Service Bulletin No: 57-007

Modification No: EC-15-0630

**WINGS - WING-TO-FUSELAGE ATTACHMENTS
CORRECT INSTALLATION OF TORLON PLATES****1. Planning Information****A. Effectivity**

All PC-12, PC-12/45, PC-12/47 and PC-12/47E aircraft which have had a wing removed between June 2007 and May 2014.

Forward Lower Wing-to-Fuselage Attachment
Figure 1

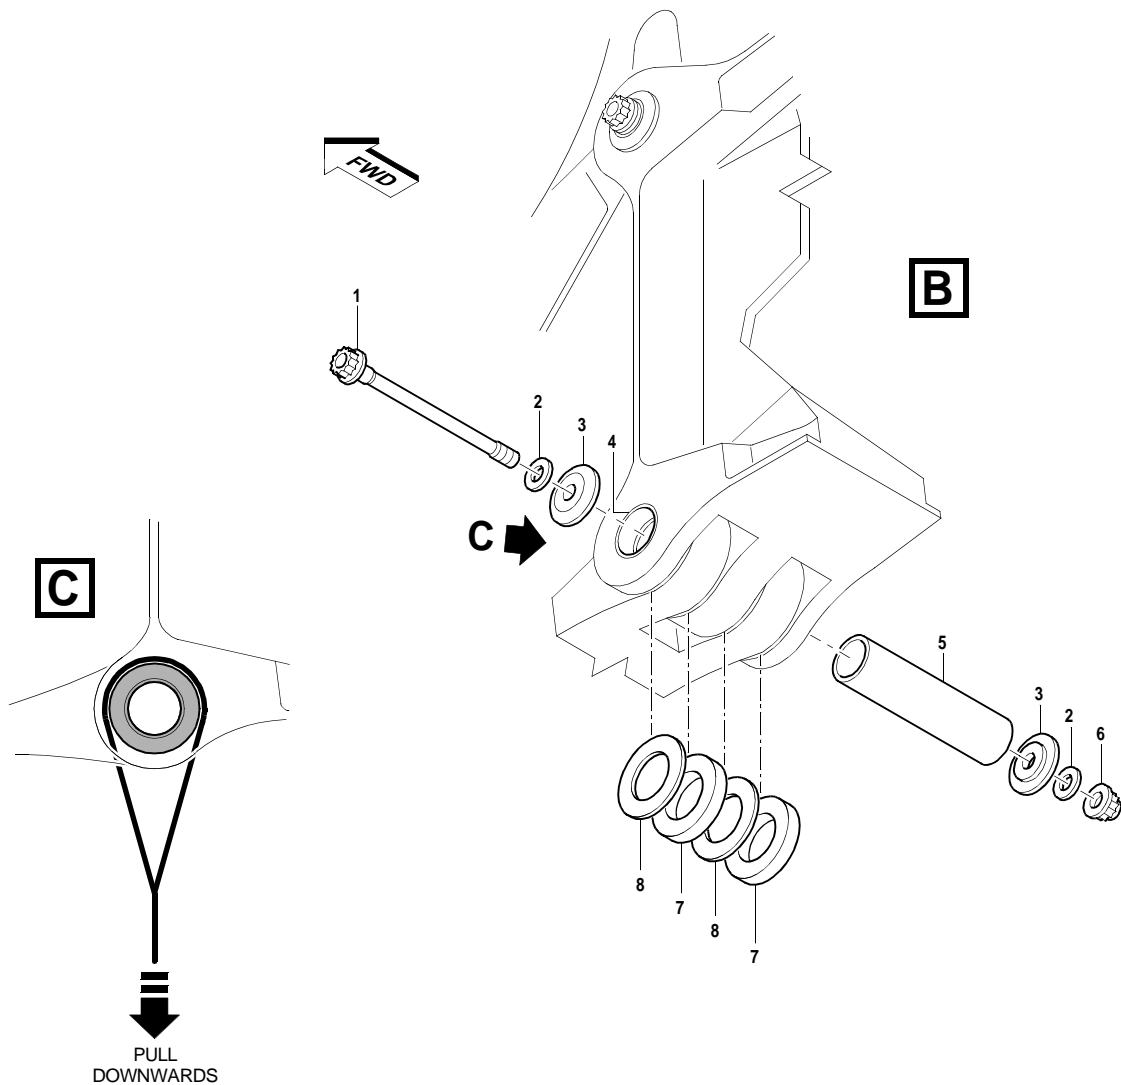
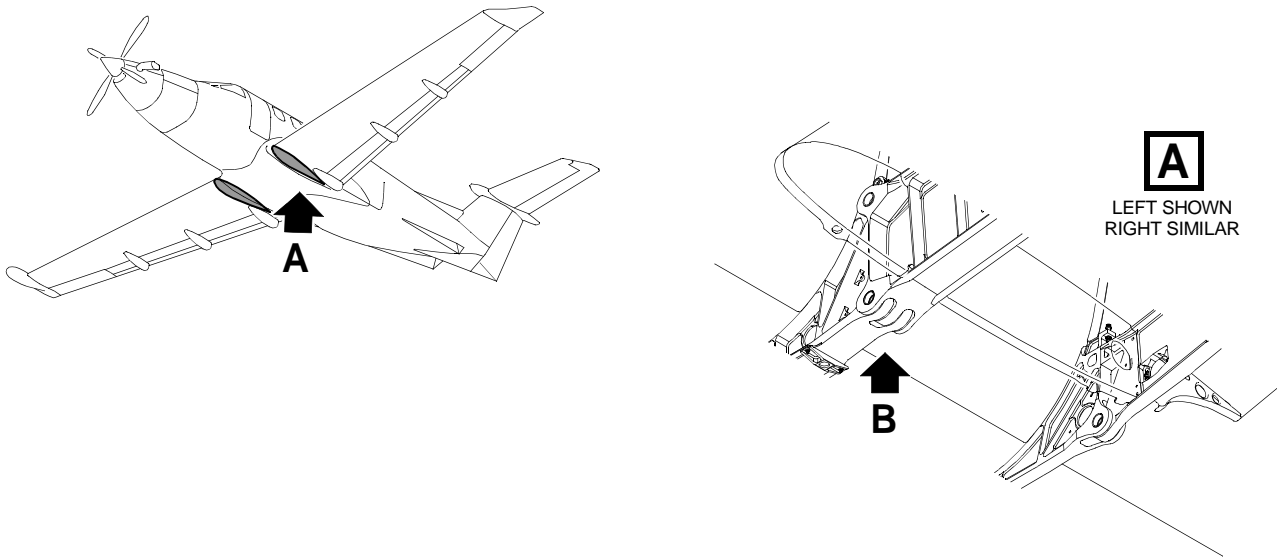
Several aircraft have been found to have the torlon plates incorrectly installed in the forward lower wing-to-fuselage attachment.

Incorrect sequence of torlon plates in the forward lower wing-to-fuselage attachment.

- (1) Inspect the sequence of torlon plates in the left and the right wing lower main spar to fuselage attachment. The sequence of torlon plates in the lower joint from forward to aft must be thin, thick, thin, thick.

NOTE: The thin torlon plates are 2,0 mm thickness, the thick torlon plates are 4,0 mm thickness.

Inspect and if necessary remove and install the torlon plates in the correct sequence.

- (6) Adjust the hydraulic jack to hold the weight of the left wing.
- (7) Refer to AMM 57-00-00-00A-520A-A (aircraft with hydraulic landing gear) or 57-00-00-00A-520B-A (aircraft with electro mechanical landing gear) and Figure 1. At the forward lower wing-to-fuselage attachment remove the nut (6), the washers (2 and 3), the tension bolt (1) and the long bolt (5).

- (10) Use pliers and pull the sling downwards to slide the torlon plate (8) out of the attachment fittings (this may take significant hand force).
- (11) Do steps (8) thru (10) again to remove the other torlon plates from the attachment joint. It may not be necessary to use screwdriver to remove the other torlon plates.

- (14) Examine the torlon plates (7 and 8). If the torlon plates are not damaged they can be re-used.
- (15) Refer to AMM 57-00-00-00A-720A-A (aircraft with hydraulic landing gear) or 57-00-00-00A-720B-A (aircraft with electro mechanical landing gear) and Figure 1. Install the forward lower long bolt and the torlon plates in the wing-to-fuselage attachment. Make sure the torlon plates are installed in the correct sequence.

NOTE: Use a new tension bolt (1) (P/N 557.10.12.055) and nut (6) (P/N 938.09.14.306) when you install the forward bottom long bolt (5).
